SUBJECT: ISSUANCE OF AMENDMENT NO. 34 TO FACILITY OPERATING LICENSE FOR THE PALO VERDE NUCLEAR GENERATING STATION, UNIT 2 (TAC NO.75372)

PALO VERDE NUCLEAR GENERATING STATION, UNIT NO. 2

Amendment No. 34
License No. NPF-51

SAFETY EVALUATION BY THE OFFICE OF NUCLEAR REACTOR REGULATION
RELATED TO AMENDMENT NO. 34 TO FACILITY OPERATING LICENSE NO. NPF-51,
ARIZONA PUBLIC SERVICE COMPANY, ET AL.
PALO VERDE NUCLEAR GENERATING STATION, UNIT 2
DOCKET NO. STN 50-529

FIGURE 3.1-1A
SHUTDOWN MARGIN vs. COLD LEG TEMPERATURE

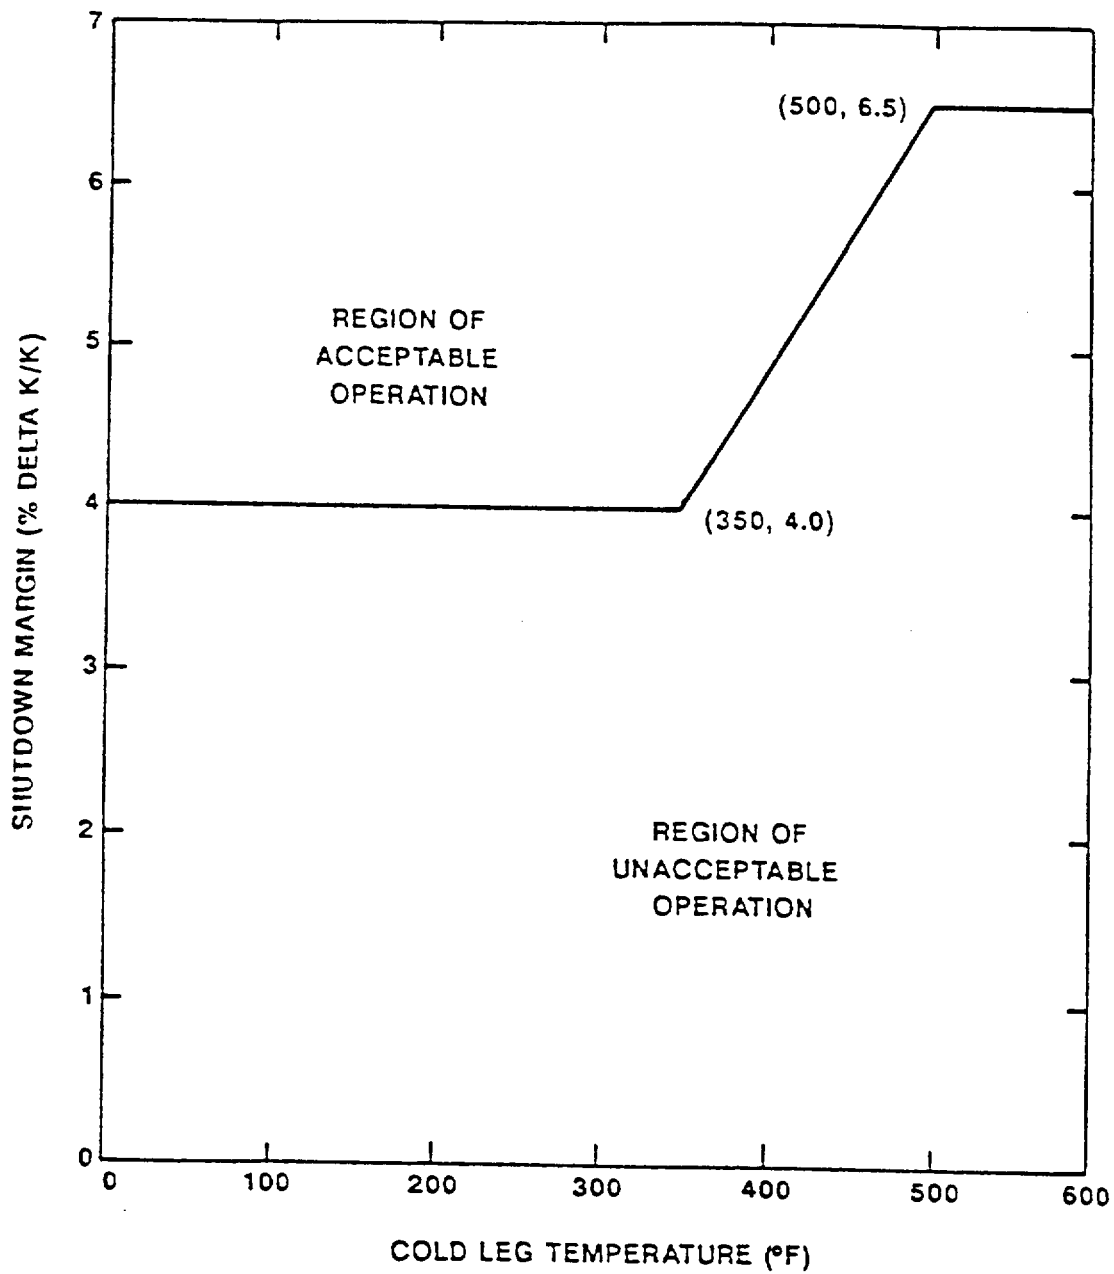
TS Figure 3.1-1A

The proposed change increases the required shutdown margin from 3.5 to 4.0% delta k/k for the RCS cold leg temperature range zero to 350°F when any full-length CEA is fully withdrawn.

The increased shutdown margin will ensure that the TS are consistent with the safety analyses performed for the Cycle 3 core and that the consequences of DBEs and anticipated operational occurrences are bounded by these analyses. The proposed change is therefore acceptable.

FIGURE 3.1-3
CEA INSERTION LIMITS vs. THERMAL POWER
(COLSS IN SERVICE)

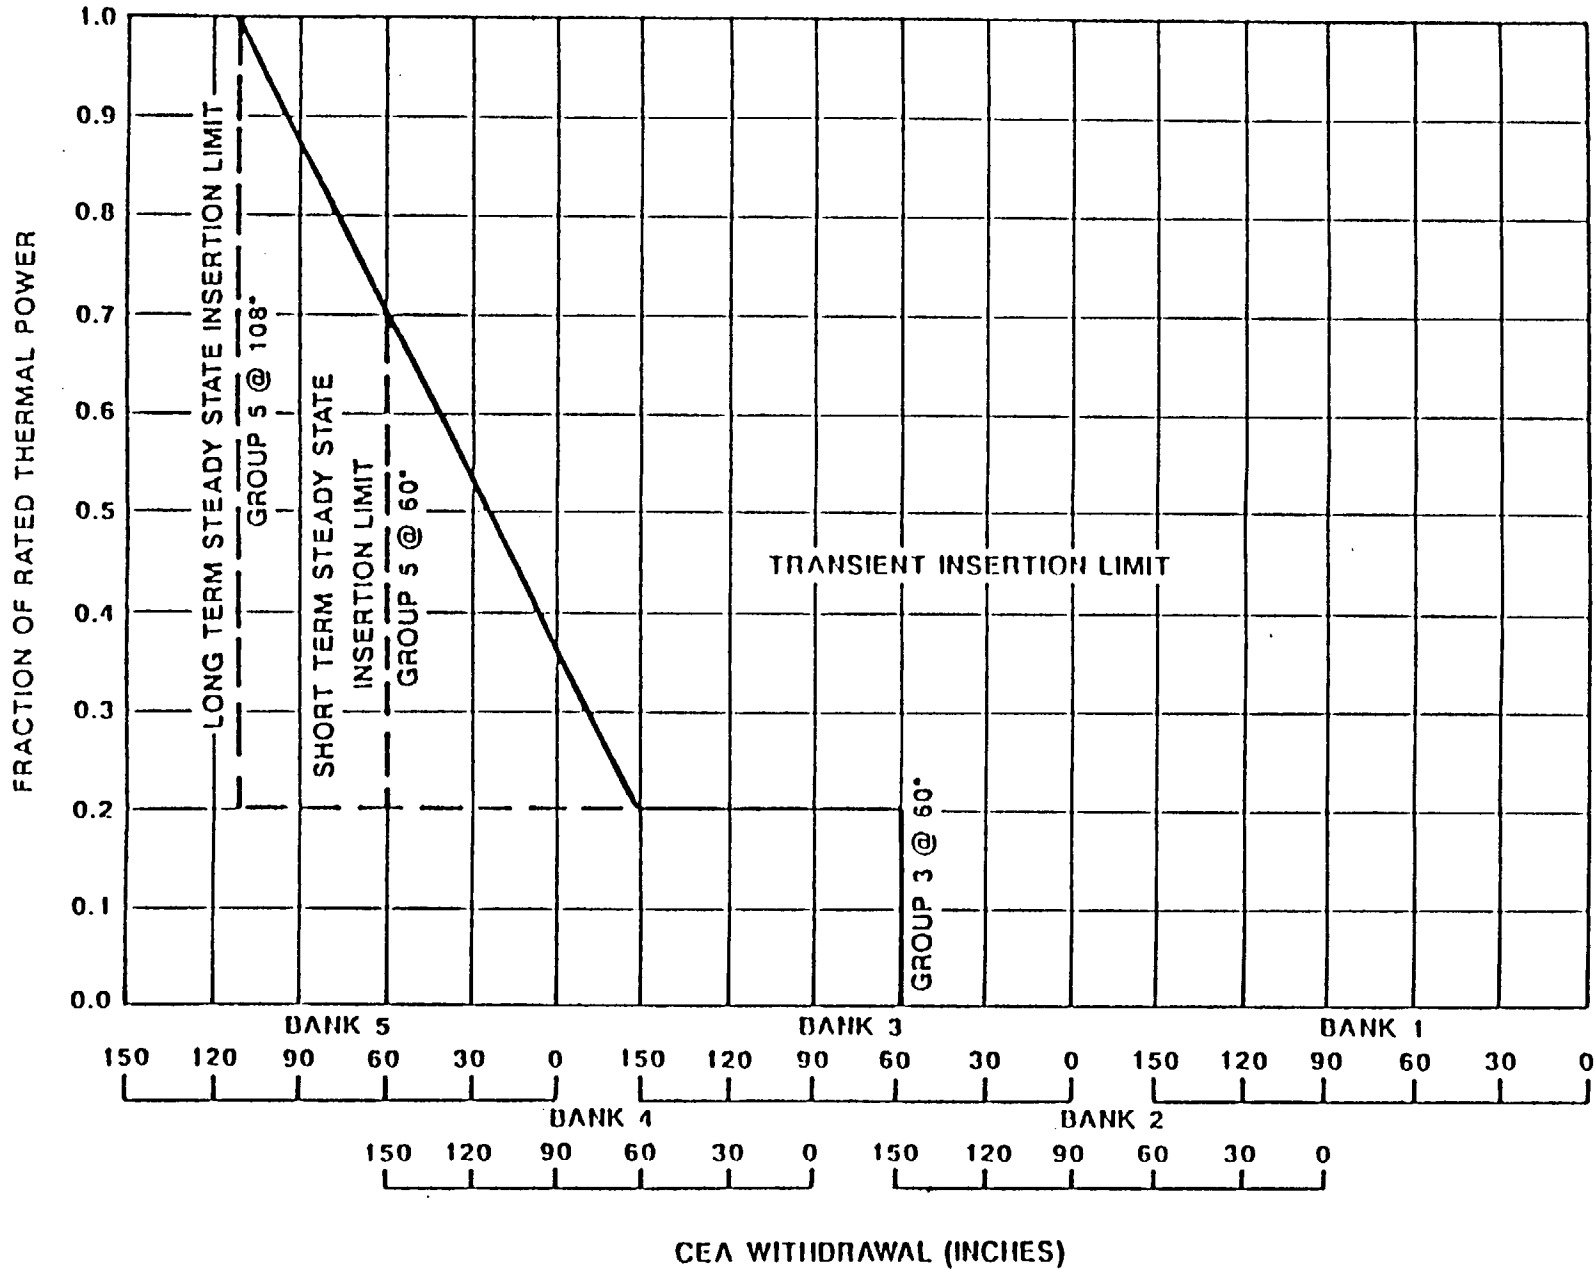
TS Figures 3.1-3 and 3.1-4

Figures 3.1-3 and 3.1-4 provide regulating group CEA insertion limits when the COLSS is in service and out of service, respectively. The proposed change to Figure 3.1-3 will prohibit insertion of regulating group 3 CEAS above 20% of rated thermal power. This is permitted under the existing TS. The proposed change to Figure 3.1-4 will permit slightly increased insertion of regulating group 3 CEAs between 15% and 20% of rated thermal power.

The proposed revisions are necessary to ensure consistency of the TS with the safety analyses performed for the Cycle 3 core. These analyses demonstrate that reactor operation in accordance with the revised insertion limits will ensure that the Specified Acceptable Fuel Design Limits (SAFDLs) will not be exceeded during the most limiting anticipated operational occurrence. The proposed changes are, therefore, acceptable.

FIGURE 3.2-2

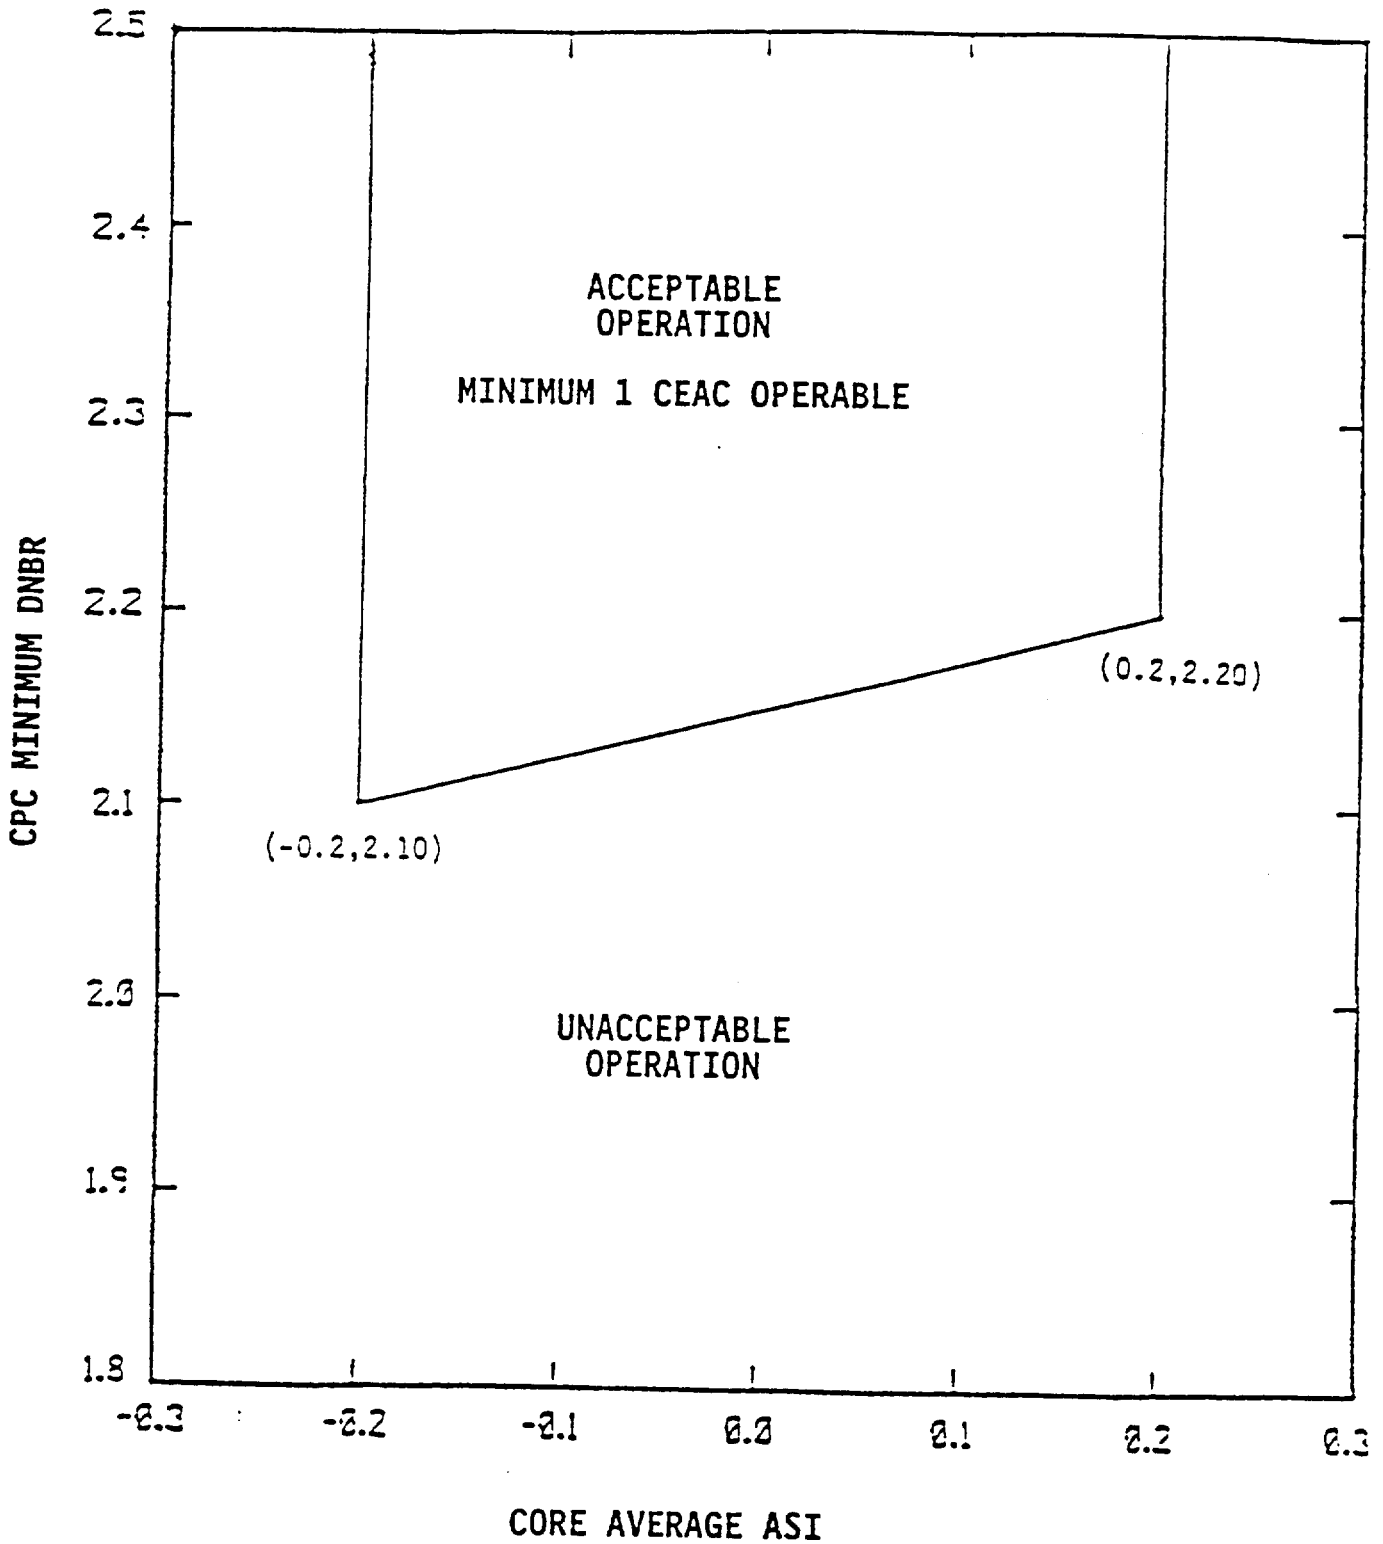
TS Figures 3.2-2 and 3.2-2A

Figure 3.2-2 provides DNBR margin limits when at least one Control Element Assembly Calculator (CEAC) is operable and the COLSS is out of service. Figure 3.2-2A provides the additional DNBR margin necessary when COLSS and both CEACs are out of service. Reactor operation within these limits ensures that the SAFDLs will not be violated during an anticipated operational occurrence.

The proposed changes are necessary to ensure consistency of the TS with the safety analyses performed for the Cycle 3 core and are, therefore, acceptable.
